Reference No: DJH059-R01

3 December 2019

REVIEW OF DAM SAFETY RISK AND PROPOSED REMEDIAL WORK ASSOCIATED WITH CATEGORY 3 NGODWANA DAM, MBOMBELA

Figure 2: Embankment internal zoning

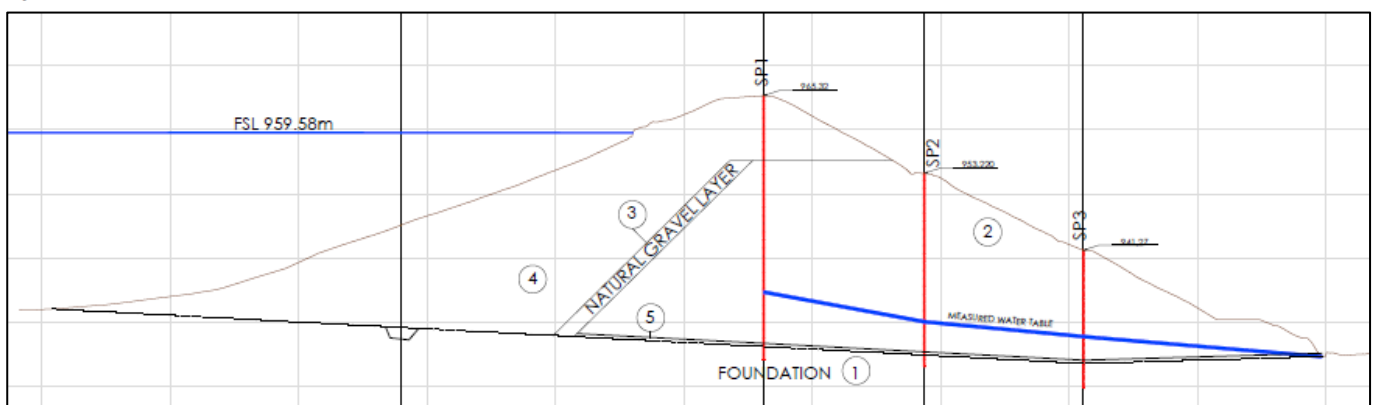
The embankment zoning is shown in **Figure 2** below. Areas of concern in this zoning are:

- The natural gravel inclined chimney drain may not comply with all filter criteria such as permeability (free-draining), collapsibility (cohesionless) and adequate protection of the base core material.
- The gravel strip drains are only for conveying seepage water from the chimney to the toe drain and do not provide continues protection to the foundation and shell zone as a filter blanket drain would have done.

Photo 19: Breaching section downstream face towards left flank (19 November 2019). Note longitudinal crack likely caused by surface slip movement.

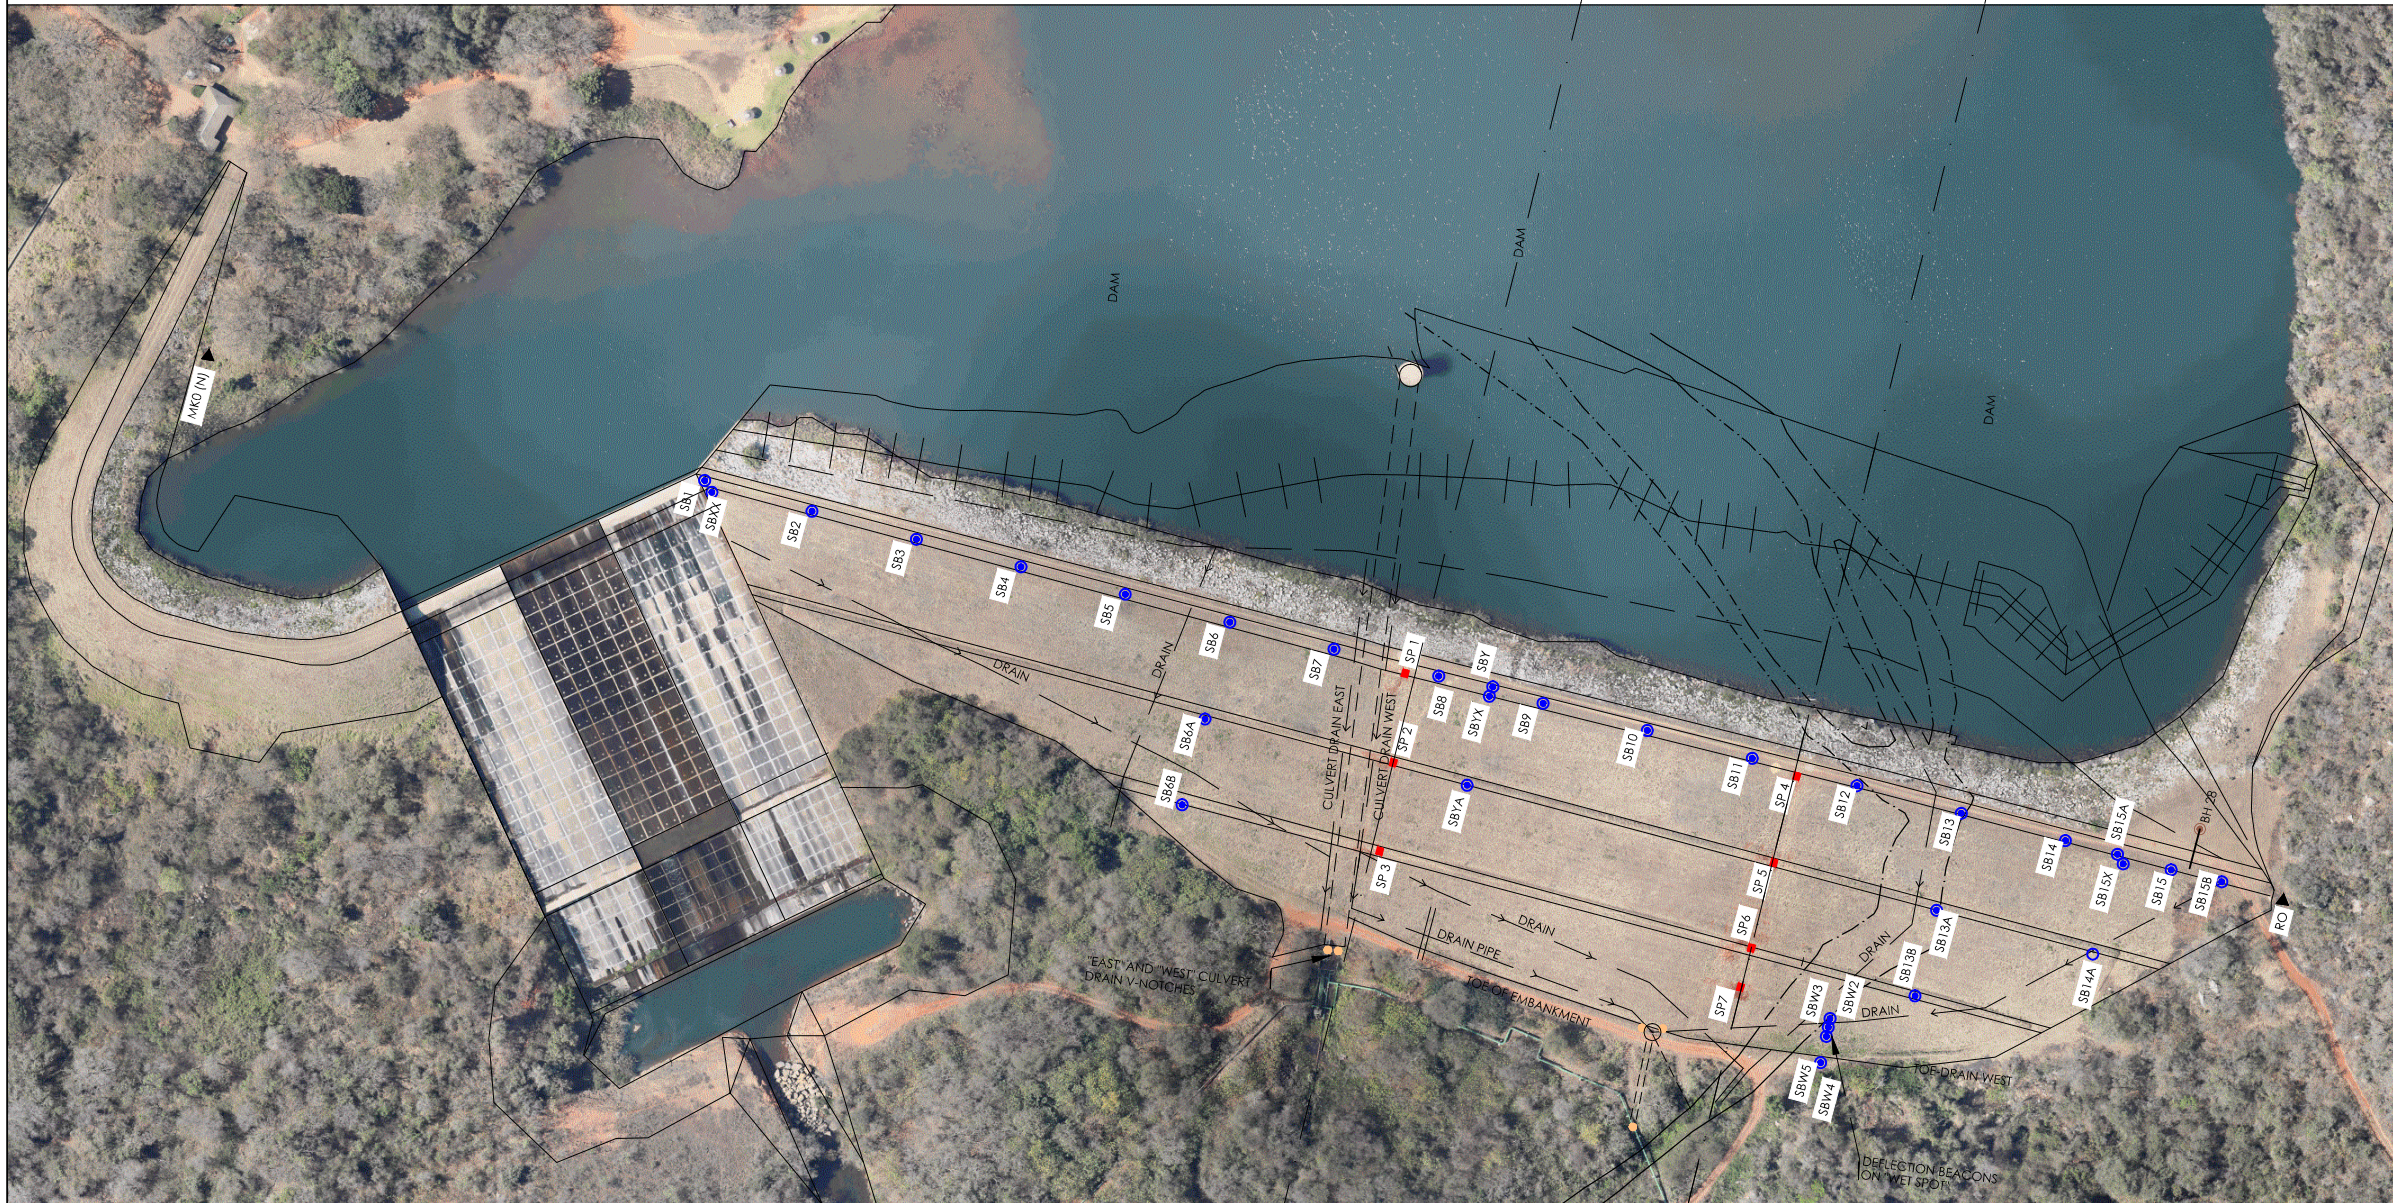
- Remedial work to the breaching section downstream face local slip (Photos 18 & 19) and possible raising of the breaching section as it is no longer considered a necessary emergency spillway.
- Repair of outlet conduit joints where water with muddy material is leaking out.
- Spillway joint sealant replacement (Photos 15 & 16).
- Removal of trees along spillway discharge channel training walls and repair of joint (Photo 17).
- Provide safety handrails alongside the spillway retaining walls (Photo 11).
- Reservoir rim stability assessment.

DESCRIPTION OF PROJECT
CROSS SECTIONS

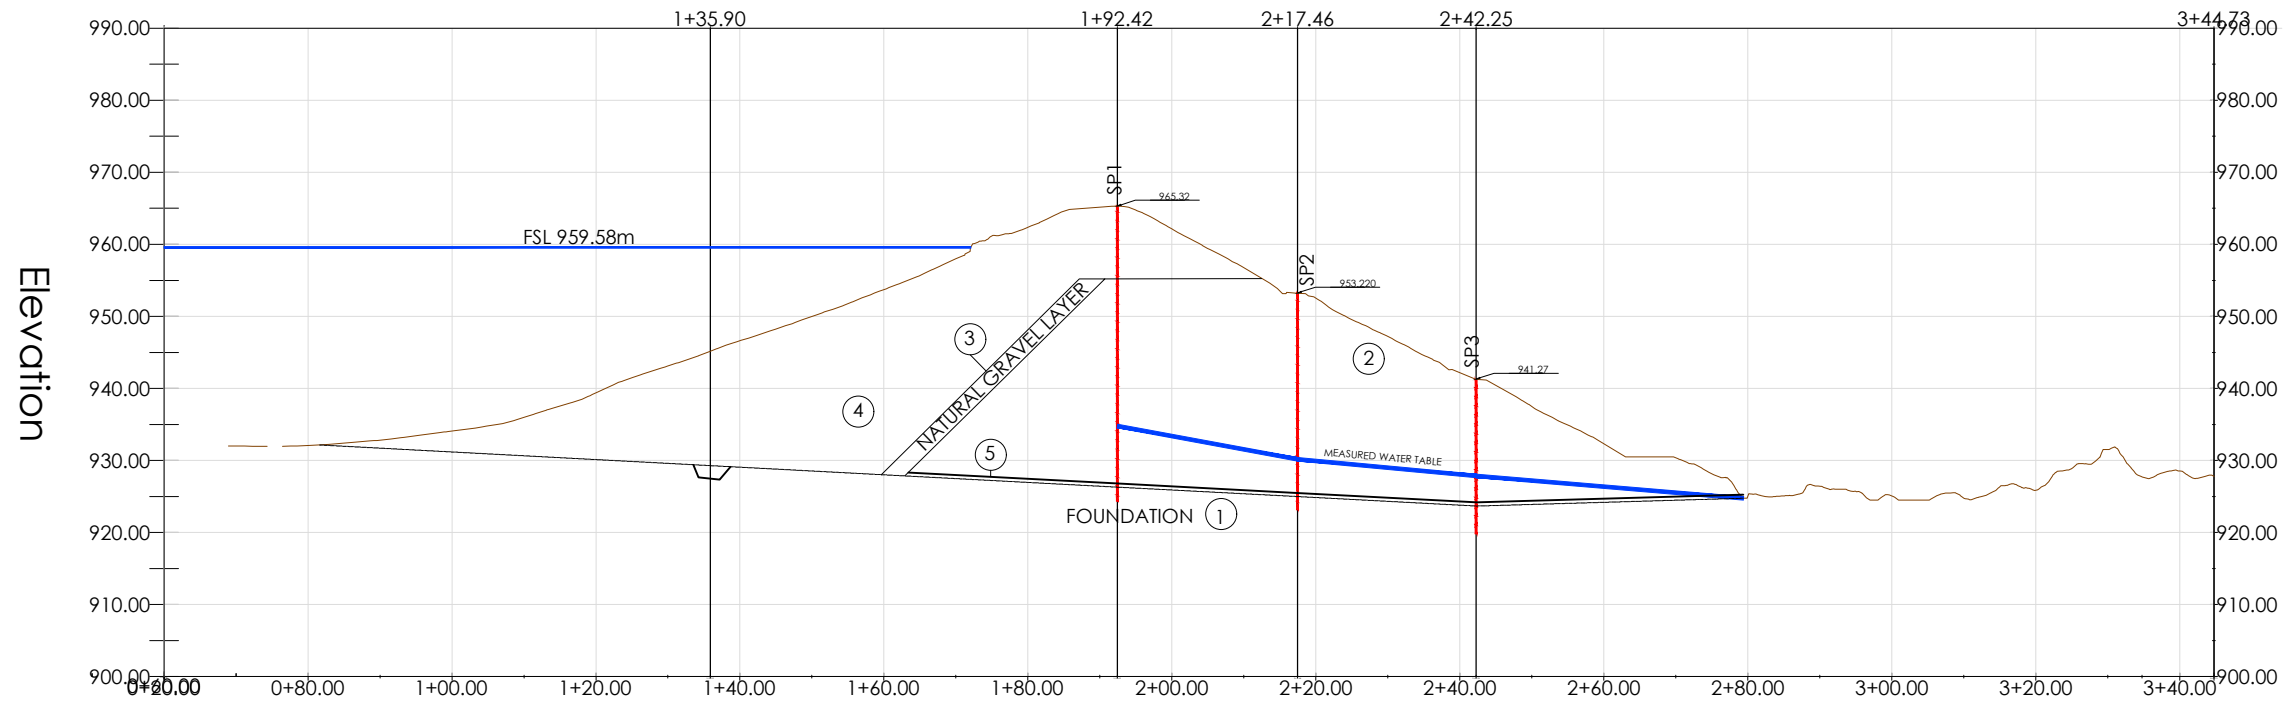
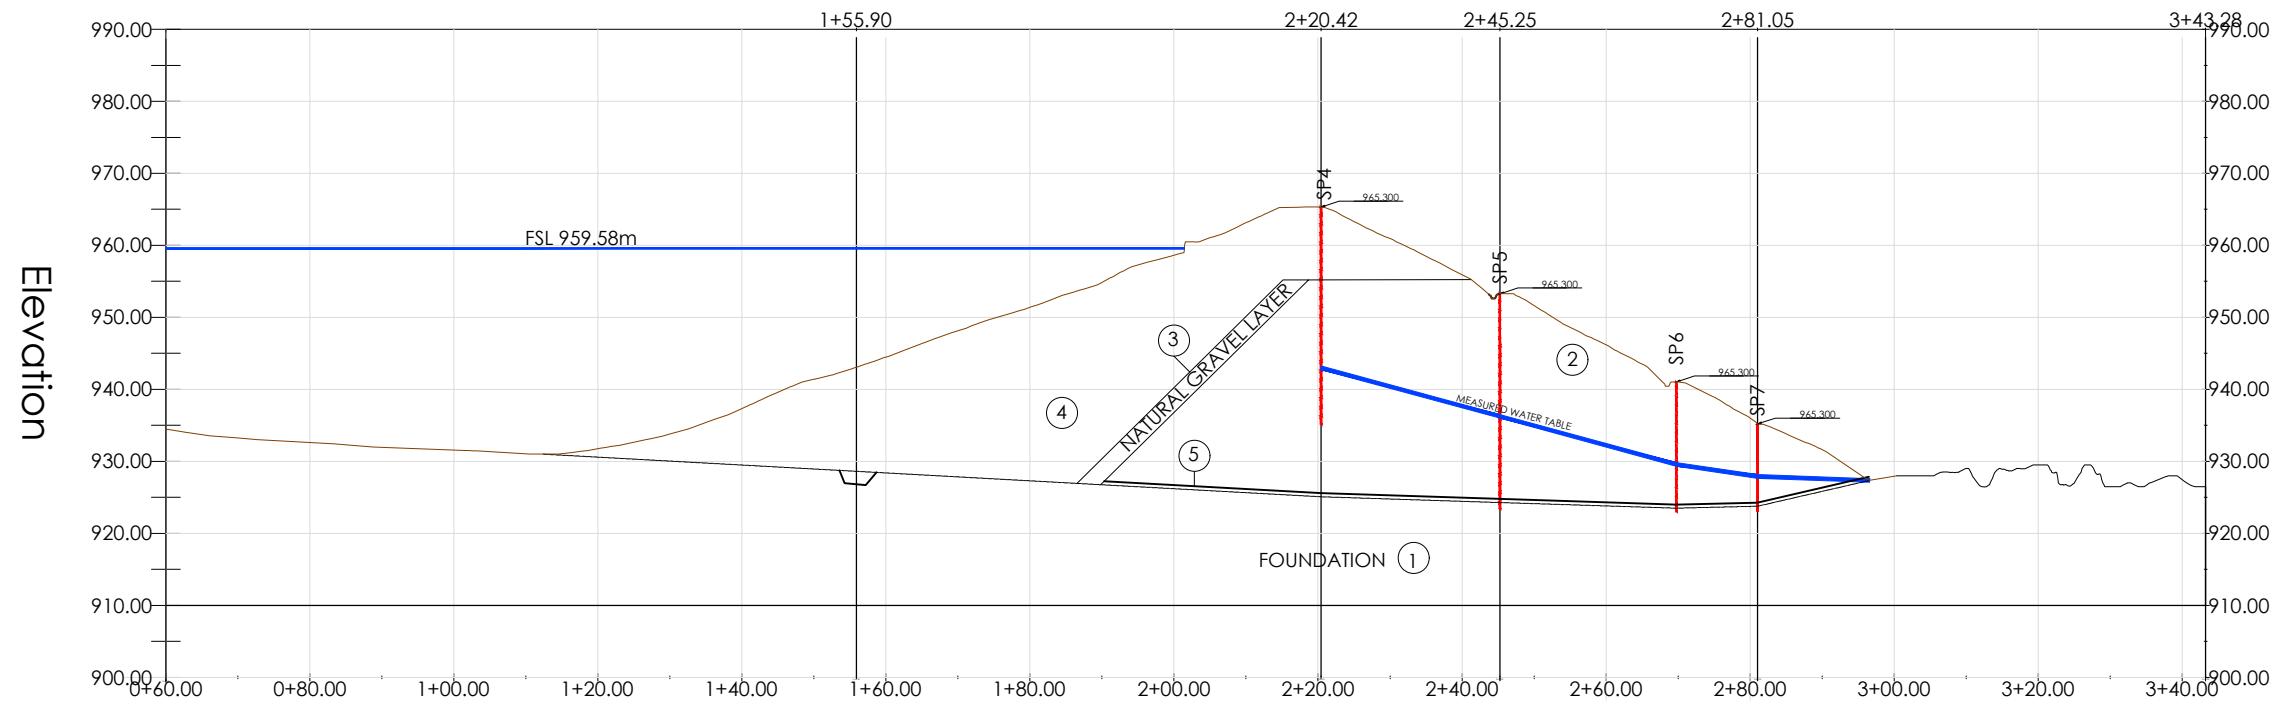
- *The 3 No piezometers at the “culvert” section show a lower phreatic surface within the embankment, but this could be due to the drains provided along this outlet conduit. The 4 No piezometers at the “riverbed” section towards the left flank show a concerning high phreatic*

surface within the embankment. This is also the area where the wet area on the lower downstream face had been observed. The high observed phreatic surface indicate that the natural gravel layer does not effectively draw-down the phreatic surface. Saturated conditions exist below the phreatic surface leading to lower shear strength for embankment materials.
